City of Corpus Christi

Meeting Agenda

Planning Commission

Wednesday, October 28, 2020

Plat of
Mary Carroll High School Tract
Block 1, Lot 1R and Lot 2

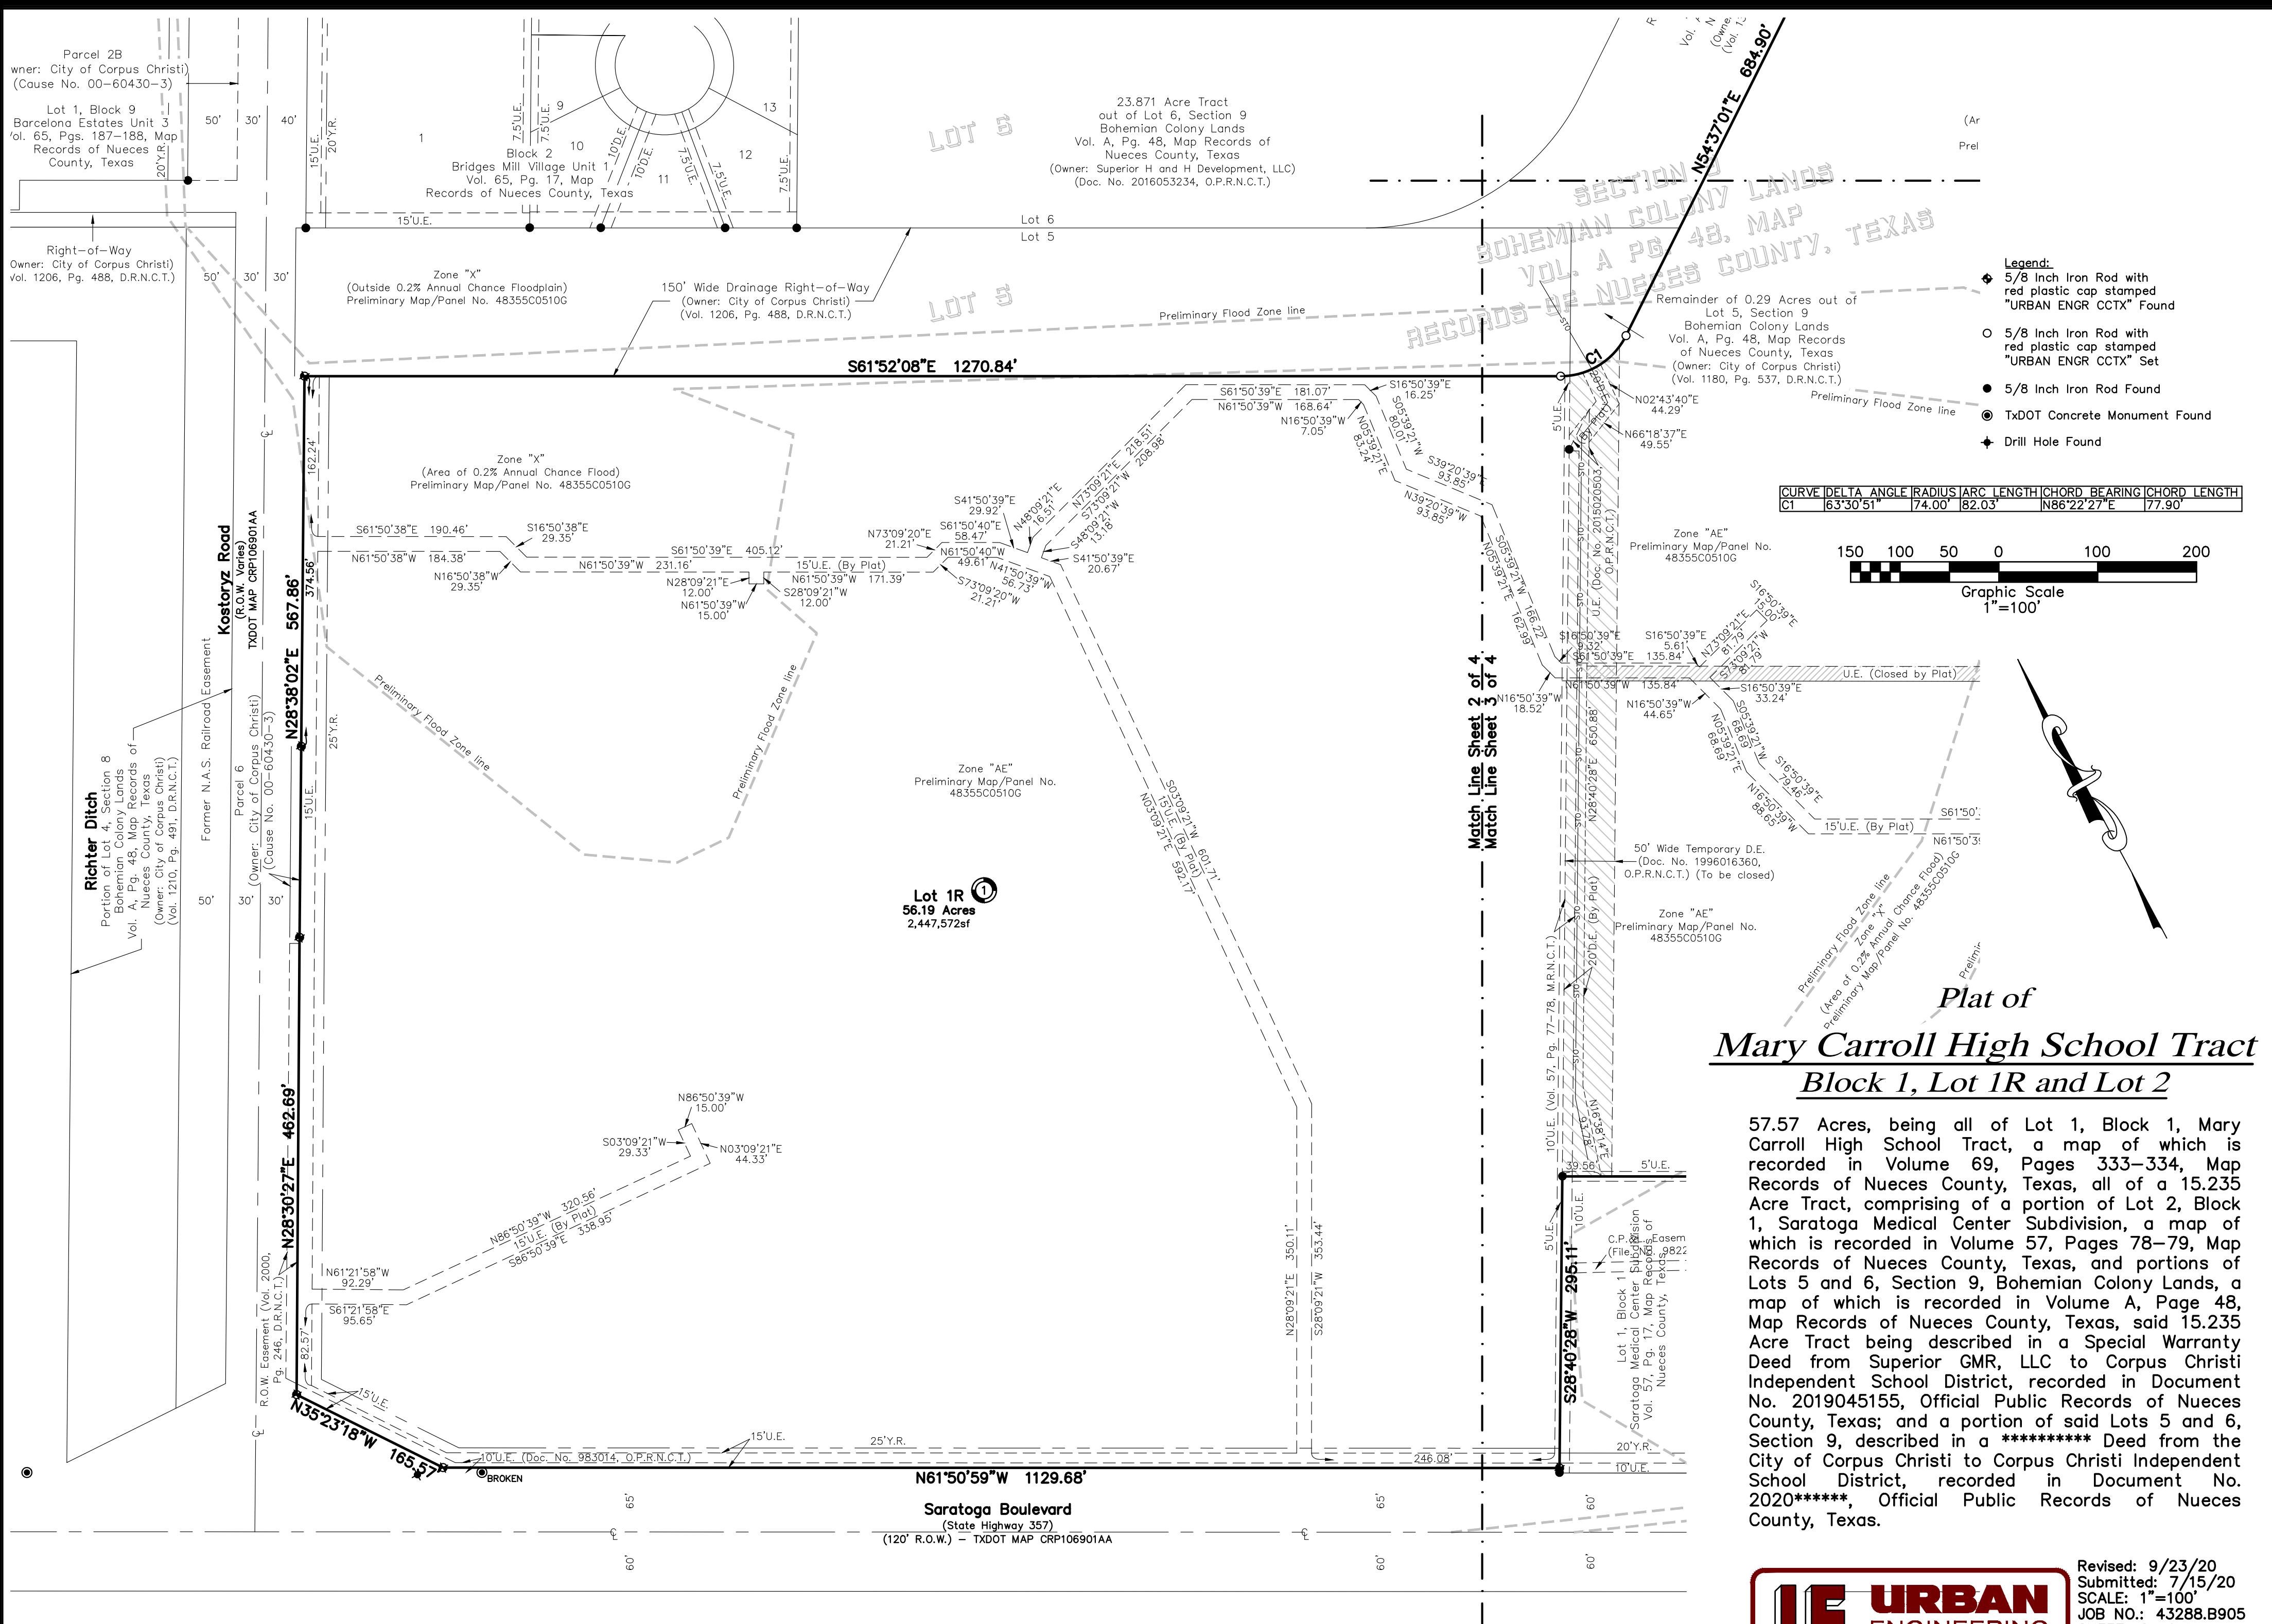
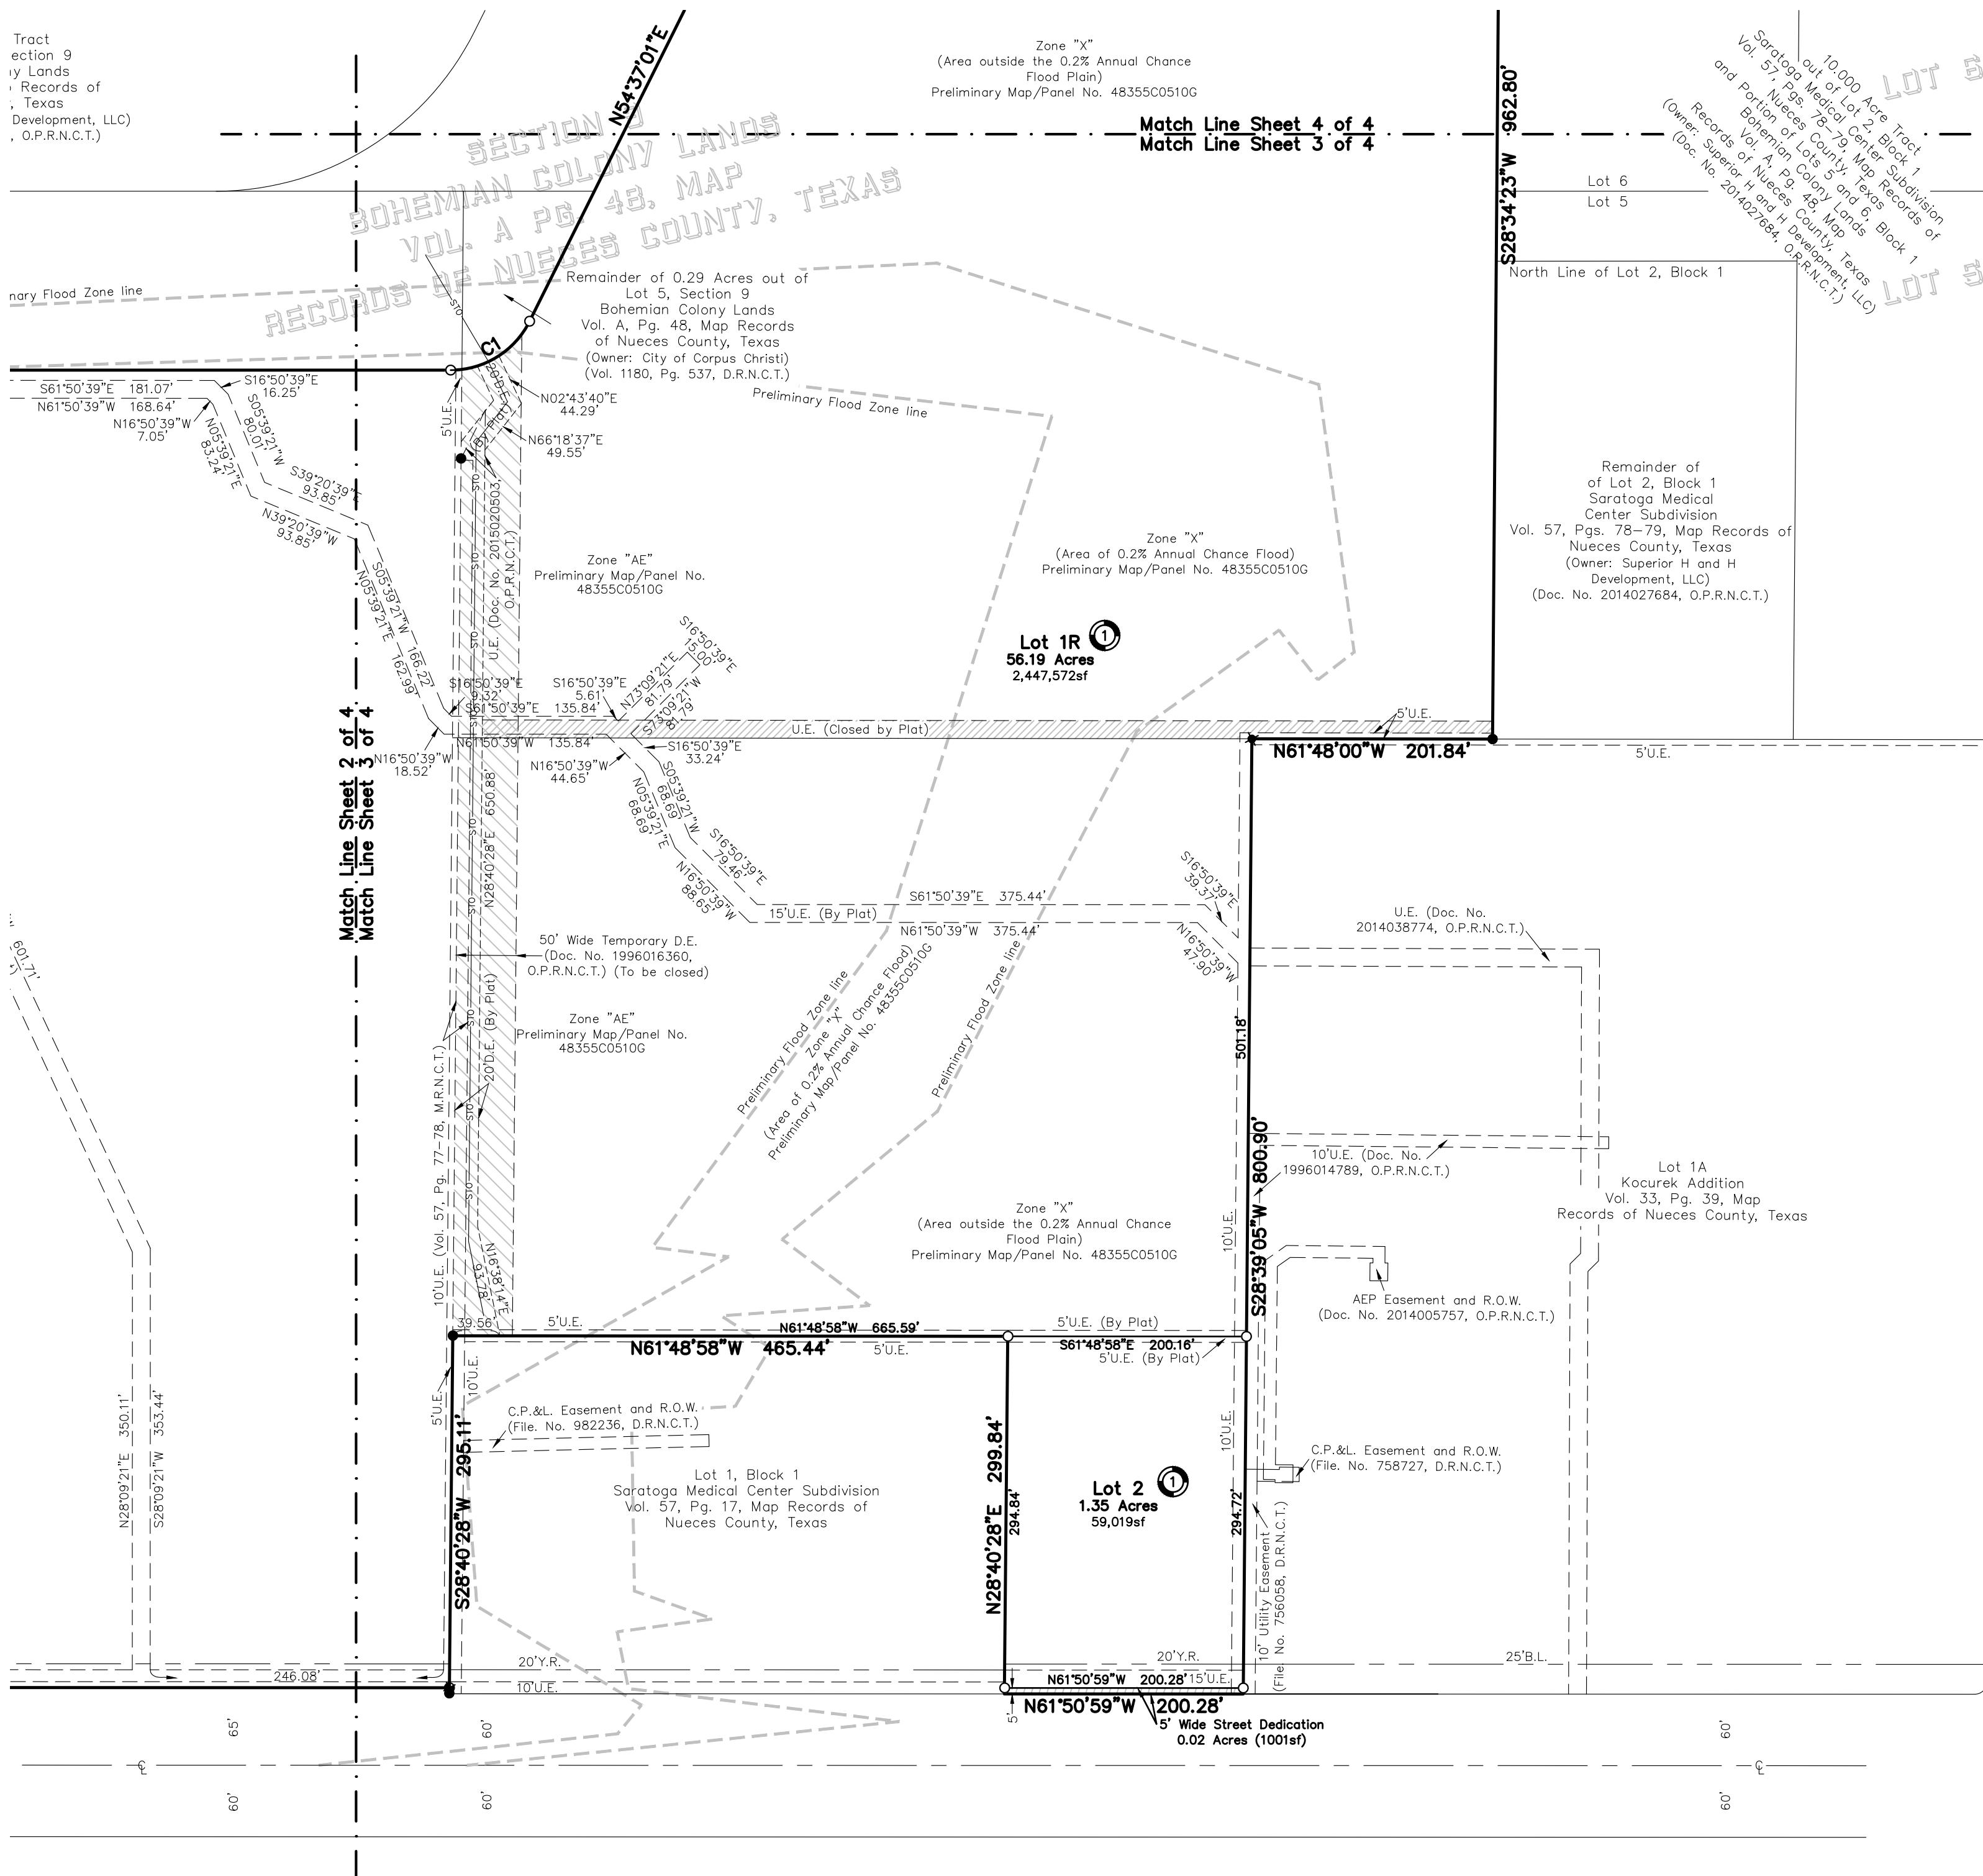
GIS						
No.	Sheet	Comment	Applicant Response	Staff Resolution	Applicant Response	Staff Resolution
1	Plat	The plat closes within acceptable engineering standards.	Understood	Addressed.

LAND DEVELOPMENT						
No.	Sheet	Comment	Applicant Response	Staff Resolution	Applicant Response	Staff Resolution
1	Plat	Provide recorded Deed document numbers for Plat description prior to recording of plat.	Understood	To be addressed prior to recordation.		
2	Plat	Provide access approval by TXDoT for Lot 2 .	Lot 2 is a remainder of an orginal platted lot and will not be owned by CCISD or part of the current development. Access to Saratoga will be permitted through TXDOT by the developer of Lot 2 at time of development.	Addressed.		
3	Plat	Update plat note 10 to include driveway access for Lot 1R.	This is covered in note 9	Addressed.		
4	Plat	Update Planning Commission certificate with Jeremy Baugh as new Planning Commission Chairman.	correction has been made	Addressed.

5 Plat	Add Utility Easement for water line stub for FH near baseball field.	Fire Hydrant will be contained within 15' Easement as shown	Addressed.		
6 Plat	Easement closing on Lot 1R to be approved prior to recording of plat.	Understood			
7 Plat	Provide a plat note indicating that the 50' Wide DE (1996016360) will be closed with plat recording. Construction of new public drainage system within the new dedicated 20' DE will be required prior to plat recording.	note has been added	Addressed.		
8 Plat	Change the 5' UE along the south boundary of Lot 1R to 10' UE for new Public Sanitary Sewer extension.	The 5' UE along the South Boundary of Lot 1R is an existing 5' easement which contains an existing sanitary sewer line which will be extended to serve Lot 2. Enlarging this easement as requested, will result in a private storm inlet falling within a public utility easement. Construction plans for the site have been approved including the location of the private storm.	Addressed.

9 Plat	Show centerline of Future Carroll Lane connection to Lot 1R as per UTP.	future connection has been added to plat	Addressed.

1	Plat	Dedicate additional 5' Right-of-way along Saratoga Blvd for a total of 65' from the Center Line to the Property Line because Saratoga Blvd is classified A3.	we are showing additional 5' dedication where required	Addressed		
2	Plat	Add the following note to the Plat document "Proposed driveway access to Kostoryz Road shall conform to access management standards outlined in Article 7 of the UDC. This includes driveway spacing, driveway widths and corner clearances."	Note has been added	Addressed		
3		Public Improvements Plans are required; submit a pdf copy of proposed public improvements along with a title sheet to PublicImprovements@cctexas.com for review and approval; this item is required prior to Final Plat Recordation. UDC 8.1.3.A	Public Improvement plans were approved on 9-22-2020	Prior to Plat recordation		
4	SWQMP	Provide the Q's for the predevelopment and postdevelopment and the differential for 5 year storm events.	This is on the submitted SWQMP	Addressed

5	SWQMP	The detention calculation provided is for the end results; provide the detail calculations and show how you got to the end results.	Detailed calculations for detention pond is a design matter not a requirement at the platting stage	Addressed
